**RIVER ISLANDS AT LATHROP  
STAGE 1 LEVEE SYSTEM**

**REPORT OF ADEQUATE PROGRESS  
TOWARDS AN URBAN LEVEL OF FLOOD  
PROTECTION**

**JUNE 2016**

**ENGINEER'S RESPONSE TO****INDEPENDENT PANEL OF EXPERTS REPORT ON THE REVIEW OF  
THE RECLAMATION DISTRICT 2062, URBAN LEVEL OF FLOOD  
PROTECTION ENGINEER'S REPORT, DEMONSTRATING ADEQUATE  
PROGRESS****PREPARED BY: RICHARD G. REINHARDT, P.E.**

Figure 1. River Islands at Lathrop Project Location Map

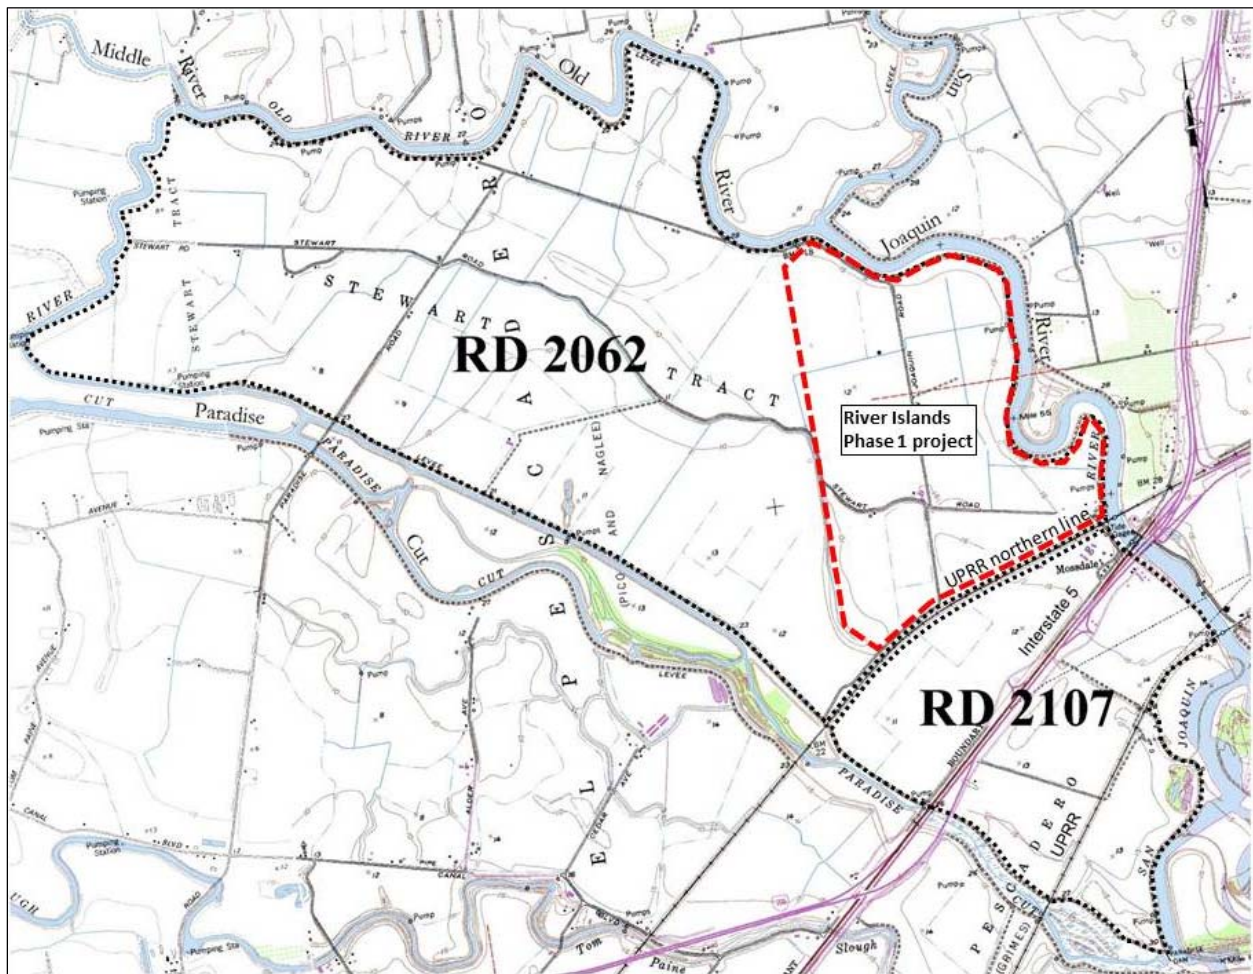
No.	LOCATION IN DOCUMENT	EXPERTS' COMMENT (January 2016)	ENGINEER'S RESPONSE (March 2016)	EXPERTS' FINAL COMMENT (APRIL 2016)	ENGINEER'S RESPONSE (June 2016)
1	Figure 1	Not all of the Perimeter levee is considered a "super levee" (ie, greater than 120 ft crown width). Also, Interior and Cross Levees do not have minimum crown widths of 40 and 50 feet as stated on Page 3 and other places in the report - according to the Levee Evaluation TM, the crown widths are as low as 27 feet for the Interior Levee and 35 feet for the Cross Levee.	Text was revised to clarify Perimeter levee crown widths vary between 60-400 feet. Crown widths of 40 and 50 are correct; ENGEO Levee Eval report was revised to reflect update levee geometry.	Response accepted, comment closed.	
2	Figure 2	The delineation of the ring levee should be updated to show the current alignment and current lake locations and configurations.	The figure was meant to show the ring levee in its original location as constructed in 2005 and not in its current configuration. The narrative and the figure will be updated to further clarify.	Response accepted, comment closed

**Figure 2. River Islands at Lathrop Stage 1 Project Levee Segments**

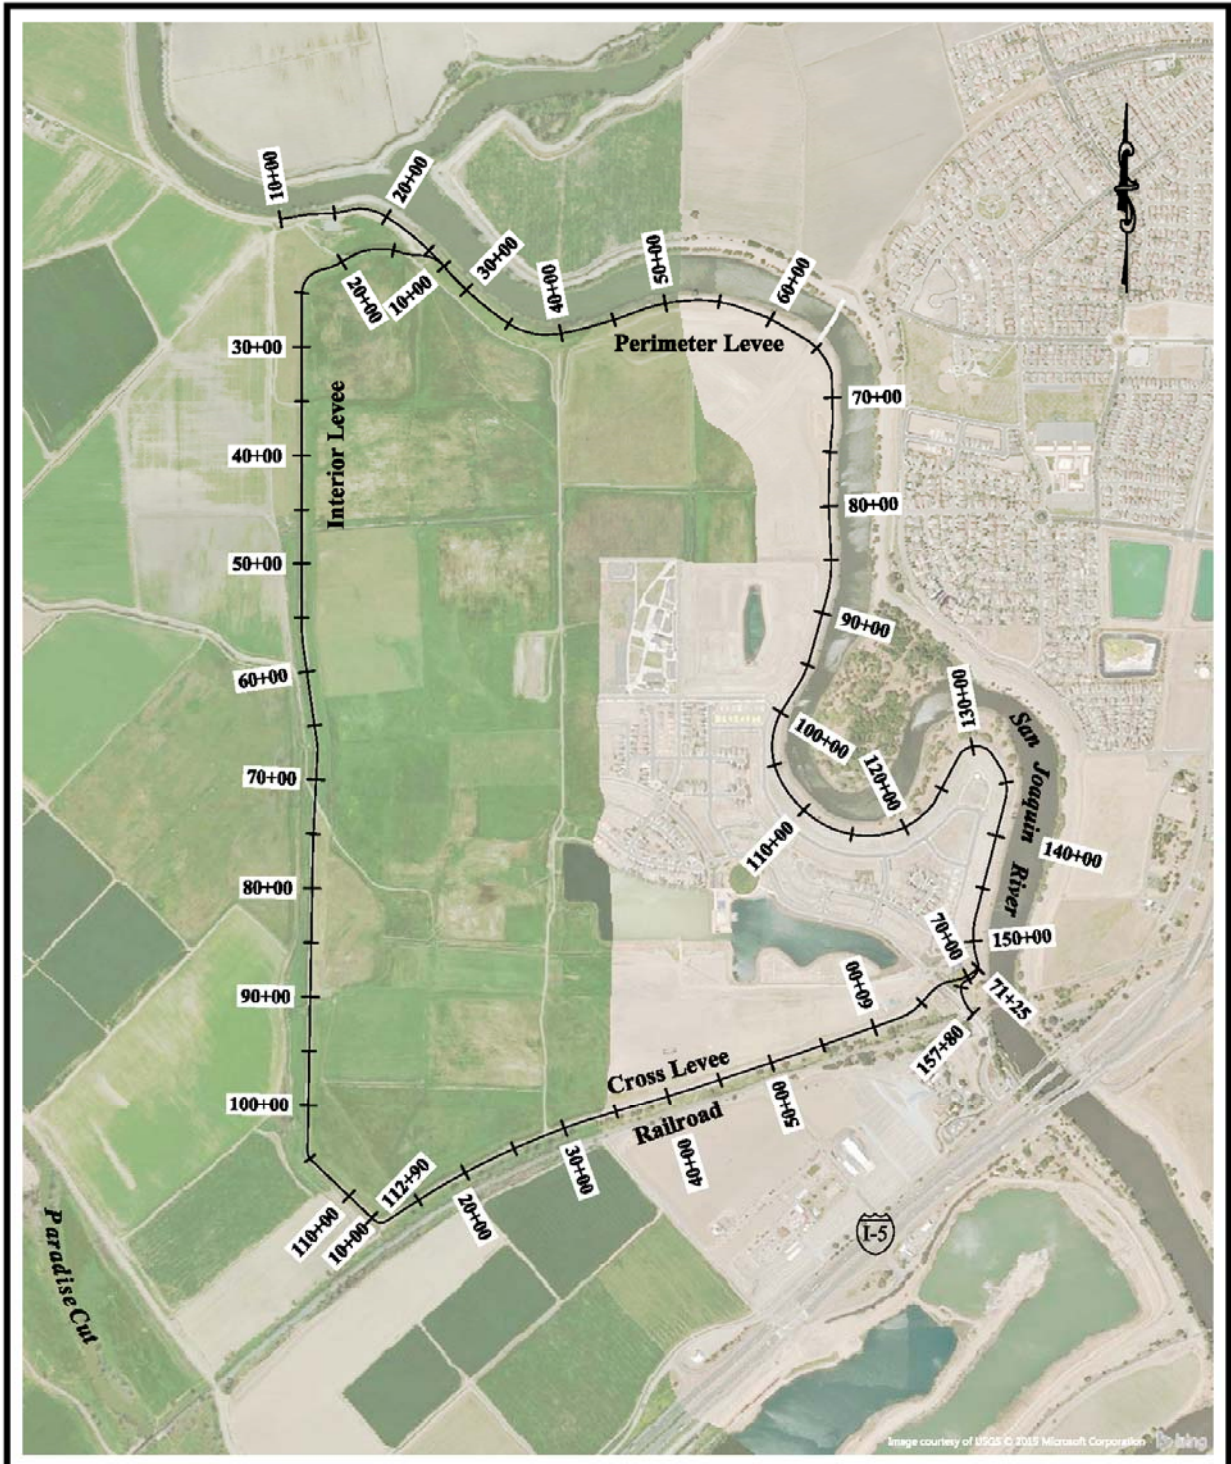
21	5.3.3 (5.4.3)	Refer to Figure 2 when describing where the inscribed landside toe is for the Perimeter levee. Should also re-label portions of the figure as it appears that the Perimeter levee is landward of the landside toe in Figure 2	See revised section 5.3.3 and Figure 2. Section now refers to Figure 2. Figure 2 has also been revised; the "Perimeter Levee" label had been updated to "Ring Levee".	The point here was to describe the inscribed landside toe from which distances would be measured to determine allowable exit gradients. Response did not address comment as Figure 2 does not show this. Please add a "dot" and label to show inscribed landside levee toe for determinations of allowable underseepage gradients.  (Response should refer to Section 5.4.3)	Inscribed toe location has been added to Figure 2.
22	5.3.4 (5.4.4)	Please show typical cross sections of the different levees at this point with dimensions to illustrate various points, particularly with regard to through seepage and underseepage.  You should also make the point that many of the levee sections represent oversized levees.  Also, where will you be summarizing the different types of soils in the different levees?	The original figure showing typical levee cross sections is no longer applicable since mass grading in the summer of 2015. Typical levee properties, including crown width, blanket thickness, and head differential are shown on the Plan and Profile.  Wide levees are discussed in Section 5.7.3.  The levee materials are discussed intermittently in Section 5.2, Section 5.3.5 (seepage parameters), and Section 5.4.2 (strength parameters)	Even if the mass grading has changed some of the landside toe elevations, the levee slopes and crown widths should be about the same. Please update figure to show typical cross sections and where they apply.	At this stage of the evaluation, we do not think that providing a new figure with typical levee dimensions will bring any more clarity to our evaluation, or provide any insight that other figures have not already provided. A figure providing typical levee crown widths has been provided on each page of the Plan and Profile, typical levee crown widths and landside and waterside slopes for each reach are included in the cut sheets, and typical levee dimensions, material properties, and construction methods are discussed in detail throughout the text. The GDR and supplementary background documents that were provided to the IPE, which are all publicly available, all contain typical dimensions and properties as well. Therefore, we are disinclined to

57	Figure No. 2	See comment above for Section 5.3.3	See revised Figure 2.	Response accepted, comment closed. (with suggested figure edits/additions)	
58	5.7 and Reach by Reach Summary	<b>Major Comment:</b> The state of practice for levee evaluations in the Central Valley is to prepare a written section for each reach summarizing: a) Heights and geometries of levee within reach b) Generalized levee embankment characteristics c) Generalized foundation characteristics d) Past performance e) Levee construction and modification history f) Penetrations or other appurtenant facilities g) Natural, physical, and land-use constraints h) Reasoning/rationale for selection of critical section i) Justification for modeling of soil layers and not using certain explorations or layering that appear to be more critical  To be sure, much of this is covered in the summary sheets for each reach, but additional justification for some of these items is incomplete, particularly documentation on the critical sites and the layering selected. Recommend adding written sections in the report covering these issues in addition to the summary sheets.	See individual Reach by Reach Summaries for revisions.	Our previous recommendation was to have written sections be added to the report to discuss each reach. The discussion would involve the characteristics of the reach and the reasoning why the locations selected for modelling were selected. In addition, several reaches have multiple model locations and discussing why these different locations were selected and the assumptions made is important. Yes, the summary tables provide some of this information, but not in sufficient detail. Also among the missing items is a discussion of the analysis results for each section and how they compare to required ULDC criteria. The summary tables present results, but do not discuss how they meet criteria. The report should discuss each reach and how the evaluations demonstrate that seepage, underseepage, and stability criteria are met. It isn't enough to simply state that they meet criteria and to look at the summary tables without more discussion.  Recommend adding written sections for all 10 of the reaches and provide requested discussion.	General geometric characteristics of each reach are provided on the Reach Summary and a discussion on analytical section selection is provided in Section 5.3. ULDC performance criteria, and the analytical methodologies used to determine compliance with the criteria, are discussed at length in the respective sections of the report and presented in graphical form within the various Appendices. As such, further reach-by-reach discussions of these items in the Conclusions Section of the report is not considered necessary.
